Kerikeri-Waipapa River Working Group
Thursday 27 March 2025 at 10:00am - 11:30am

Peer Review of the Multi-Purpose Dam Proposal: "Blueprint One"

Review of the Multi-Purpose Dam Proposal: "Blueprint One": Hydrological Analysis

Figure 2: Lake Waipapa Inflow hydrographs scaled up for 24hr storm event

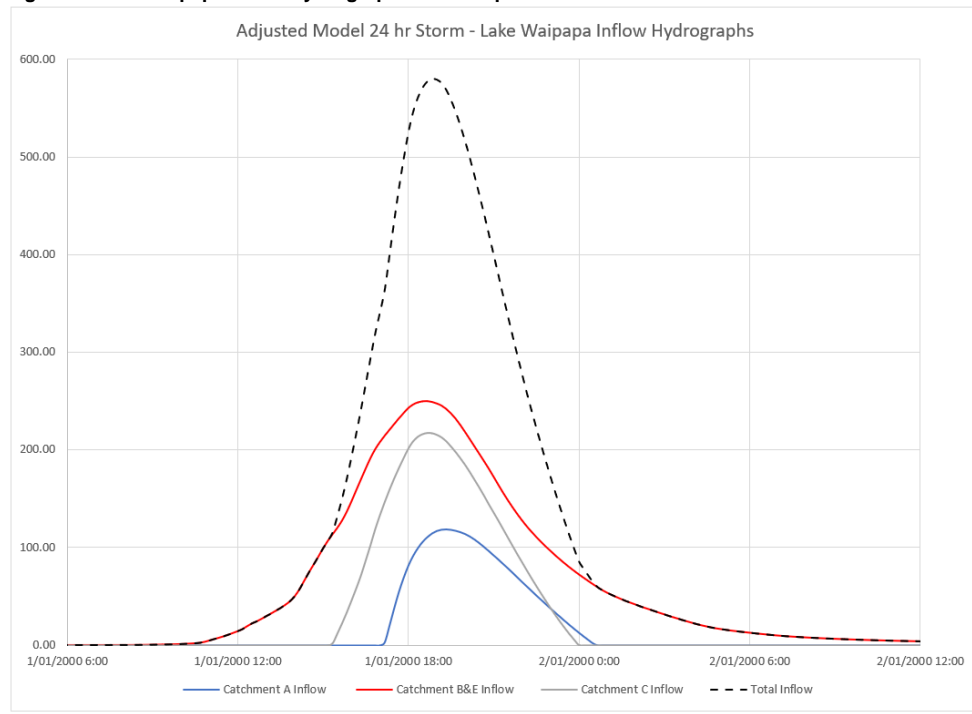
Total estimated inflow volume from catchments A, B, C and E is 12.7 Million m³ for the 24hr event. The estimated lake outflow during this event is approximately 4.3 Million m³ over 12 hours (up to peak lake level). Approximately 8.4M m³ of attenuated flood water remains in the lake at the time peak inflows drop below 200m³/s (refer Figures 2 and 3 below).

The estimates above indicate that the design 1%AEP + CC event can be attenuated as proposed by diverting flows into Lake Waipapa. The flood detention provided would limit peak flow in each of the river channels to 200m³/s at the SH10, with additional discharge from the lake of up to 200m³/s occurring approximately 3 hours after flood peaks in the main channels. The estimated utilised flood storage volume, allowing for inflows and outflow is 8.4 Million m³/s.

Figure 3: Lake Waipapa Storage Curve and Estimated Volume Utilised at Peak Lake Level

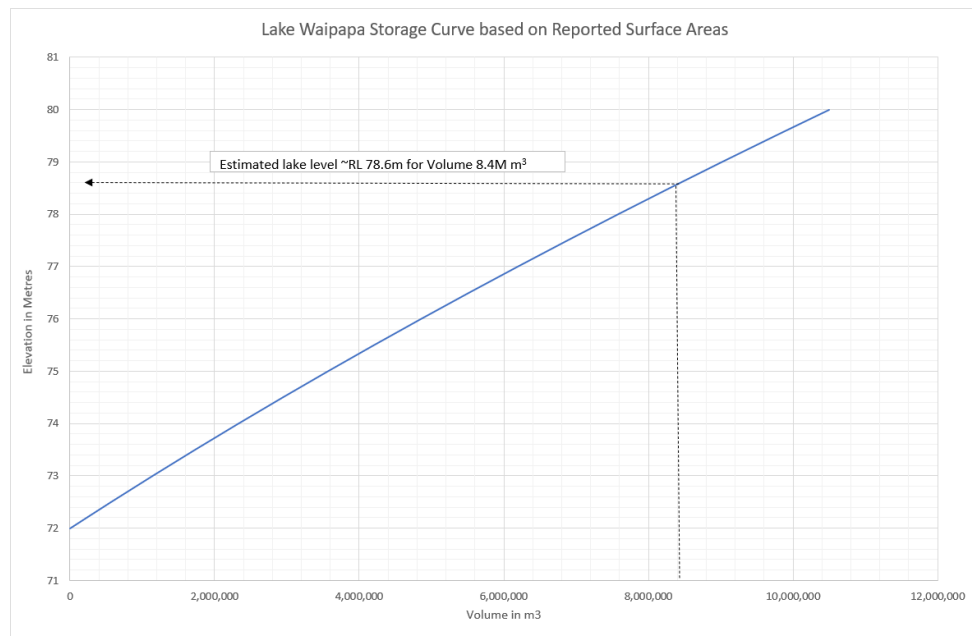
The storage curve above has been estimated using the approximate lake surface areas for RL 72m and RL 80m provided in the PKE report, and assuming that surface area increases linearly with elevation. Lake surface area at RL 80m has been checked using the NRC natural hazards portal area measurement tool and appears to be close to 150 Ha.

Figure 4: Alternative spillway alignments for diverting Kerikeri River flows into Lake Waipapa

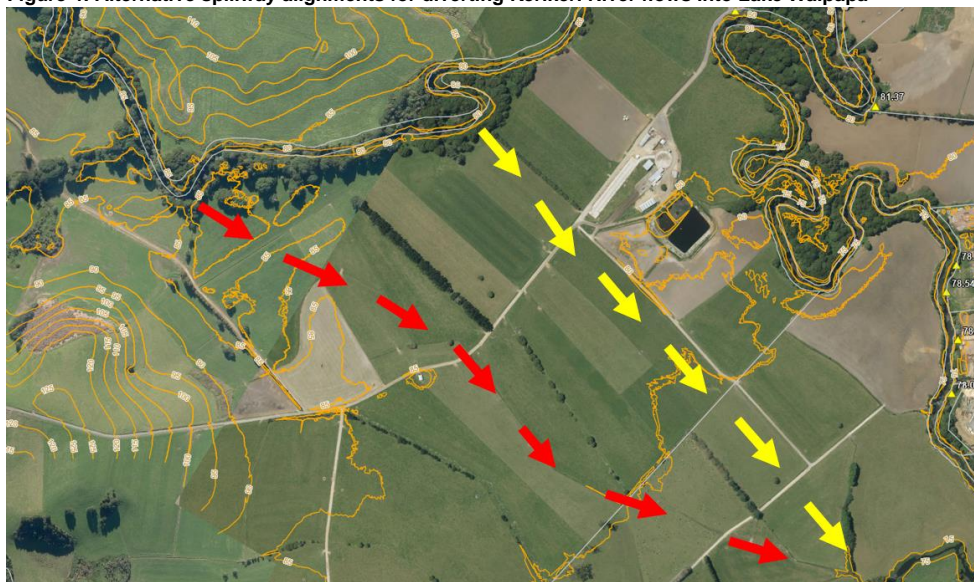
For the Kerikeri River the control weir is located in the vicinity of vegetated river loops to the West of the Waipapa Industrial Estate. Forming a control structure in this area is likely to prove challenging, as it will require significant removal of vegetation and the hydraulics of the channel are complicated due to the river loops. River bank scour will need to be addressed in this area to reduce risk of diversion structures being undermined. The PKE plan also shows a bund on the true left bank of the Kerikeri River in the vicinity of the river loops which is required to prevent overflow into the Whiriwhiritoa Stream catchment.

Diverting Kerikeri River flows to Lake Waipapa further upstream would either remove or reduce the need for bunding on the true left bank adjacent to the industrial estate. The alternative spillway locations shown in figure 4 divert flows from the river where there are fewer meanders to complicate design of the flow bifurcation and the river channel appears to be more stable in this area.

The construction of a high bund on the true right bank of the Kerikeri River adjacent to the industrial estate would transfer any channel overflow to the left bank, into the Industrial Estate. It is possible that risk of this is low for the design event, due to upstream diversion, however the bund may exacerbate flooding of the Industrial Estate for a PMF event. Removal of the section of the bund on the true left bank would reduce the risk to the industrial estate in a PMF event, as overflows would occur as they do currently, across farm land and into the Whiriwhiritoa Stream.

Figure 5: Proposed and Alternative diversion channel alignment for the Puketotara Stream

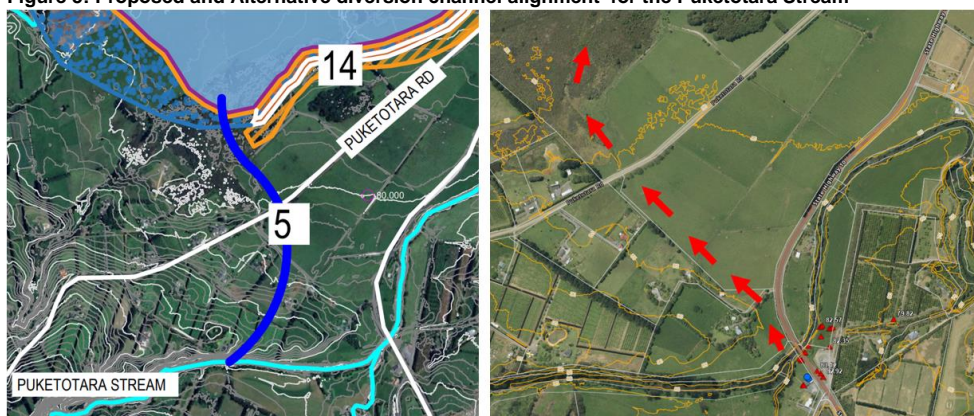
The location of the Puketotara Stream diversion is proposed in the report to be upstream of the confluence with the Waiwhakarongaro Stream. The diversion channel as shown would require a 10-15m deep excavation through the ridge that runs along the North side of the Puketotara stream. Locating the intake to this diversion channel further downstream would have several benefits including: reduced earthworks cost and environmental footprint, reduced impact on private property, and more certainty in terms of regulating lake by-pass flows as it is downstream of the confluence with the Waiwhakarongaro Stream. There is one access drive to several private properties which would either require a spillway crossing, or the accessway could be realigned to connect to the Puketotara Road.

The ground level at the proposed intake immediately upstream of the SH10 is RL 83m – RL 84m. If the invert level of the intake was below RL 80m (eg. RL 78m-79m), this would potentially allow the channel to back flow when lake levels were high. However this may also result in excessive diversion unless a weir structure was put in place with flap gates or some other mechanism to regulate flow direction.
